QUESTIONS AND ANSWERS
ITB 2022-04 Adaptive Frequency Drive (AFD) Chiller Control
Room

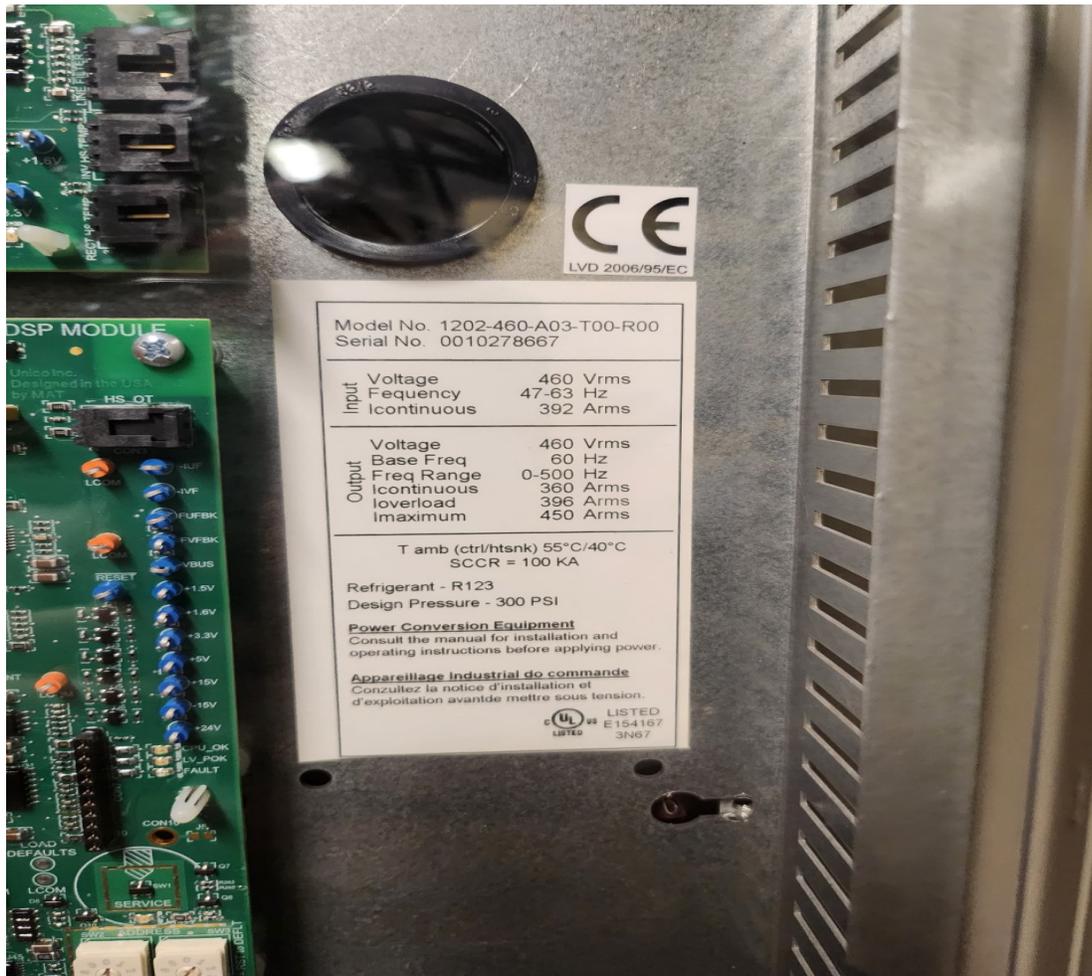
Is there any way you guys could provide a picture of the nameplate on the drive or the spec sheet of the drive so that bidders are able to see what kind of drive you are looking for, that would be great.

ANSWER 1
